ADDENDUM TO THE CONTRACT

**West Douglas Pioneer Road
Contract No. BE17-039**

ADDENDUM NO.: THREE

DATE ADDENDUM ISSUED: September 19, 2016

SOFT GROUND CONSTRUCTION DETAILS

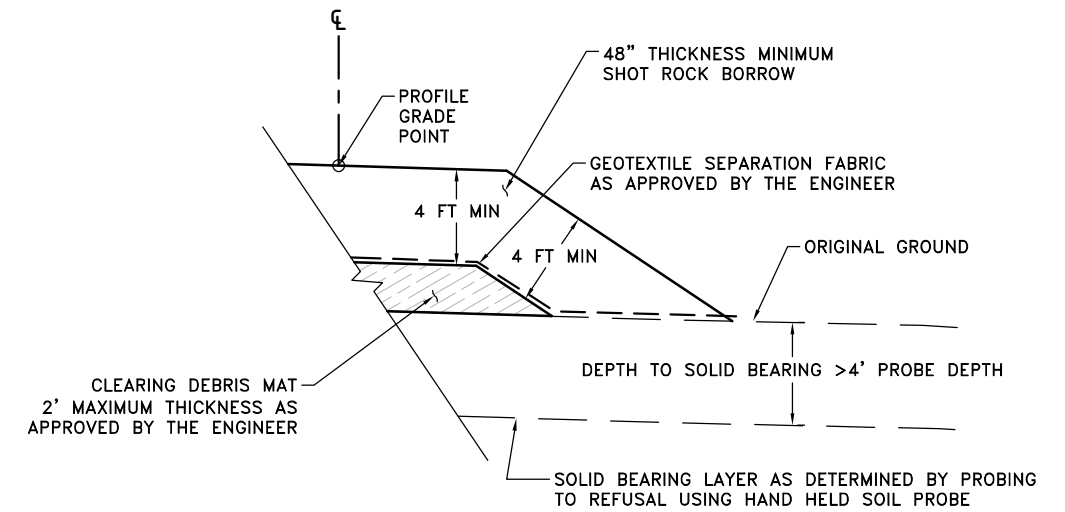
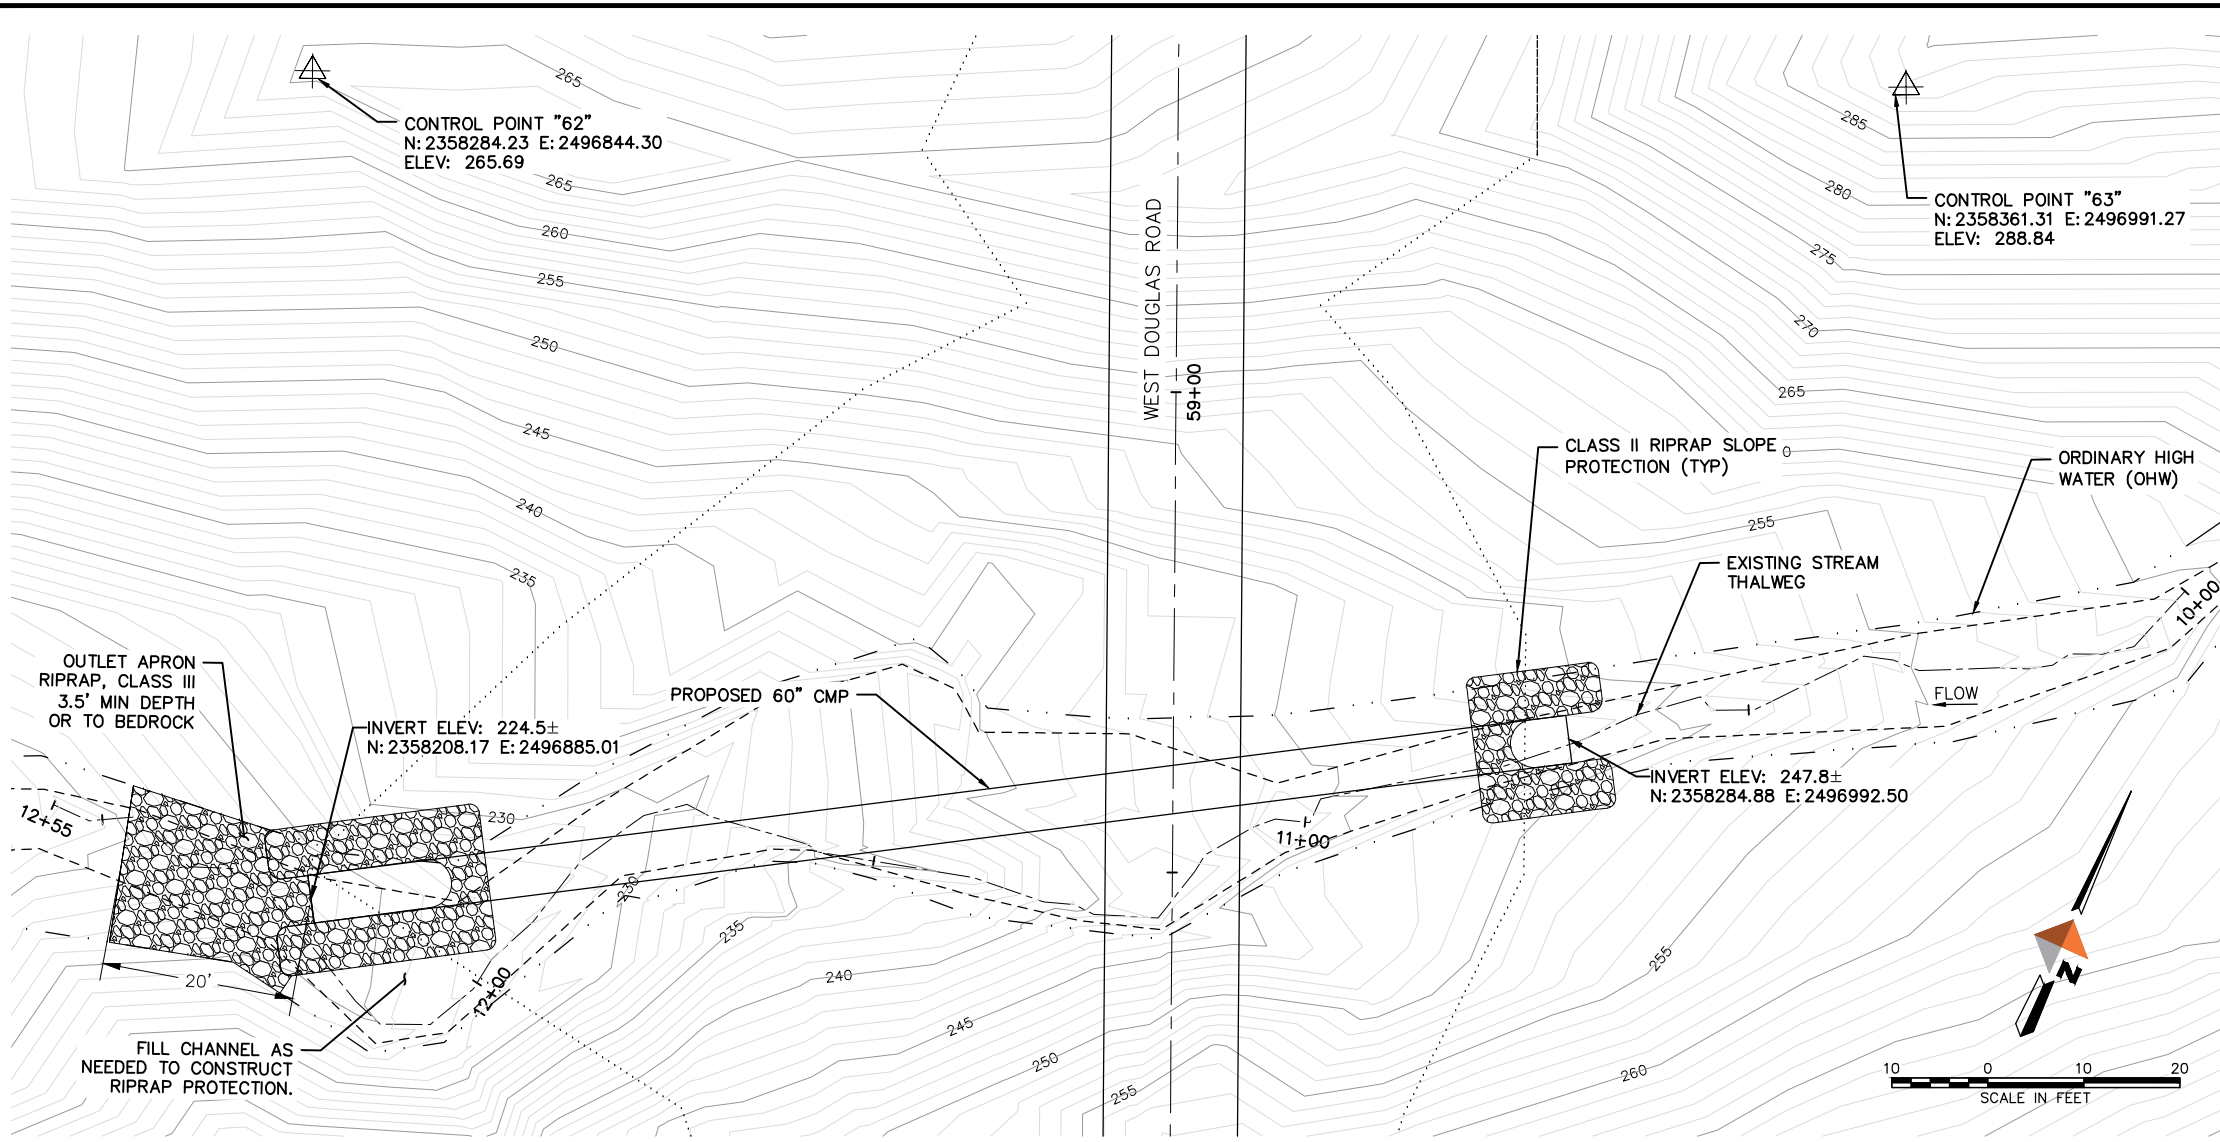
- Item No. 1 Sheet No. 9/23 - SOFT GROUND CONSTRUCTION DETAILS. **Delete and replace with the attached** Sheet No. 9/23 - SOFT GROUND CONSTRUCTION DETAILS, labeled Addendum No. 3.
- Item No. 2 Sheet No. 17 of 23 - MAJOR STREAM CULVERT: STAT 59+50 – STREAM PLAN AND PROFILE. **Delete and replace with the attached** Sheet No. 17 of 23 - MAJOR STREAM CULVERT: STAT 59+50 – STREAM PLAN AND PROFILE, labeled Addendum No. 3.

1. IF SOLID BEARING IS 4 FT OR LESS BELOW EXISTING SURFACE, CLEAR, STRIP AND EXCAVATE UNSUITABLE MATERIAL BEFORE PLACING SHOT ROCK EMBANKMENT.
2. IF SOLID BEARING IS GREATER THAN 4 FT BELOW EXISTING SURFACE, PLACE 4FT MINIMUM THICKNESS SHOT ROCK EMBANKMENT. PLACEMENT OF GEOTEXTILE SEPARATION FABRIC BELOW EMBANKMENT REQUIRES ENGINEER'S APPROVAL.

4. ALL TREE STUMPS NOT GRUBBED SHALL BE CUT FLUSH TO SURFACE PRIOR TO PLACEMENT GEOTEXTILE SEPARATION FABRIC AND SHOT ROCK BORROW FILL.
5. GEOTEXTILE SEPARATION FABRIC WILL ONLY BE PLACED WITH PRIOR APPROVAL BY THE ENGINEER.
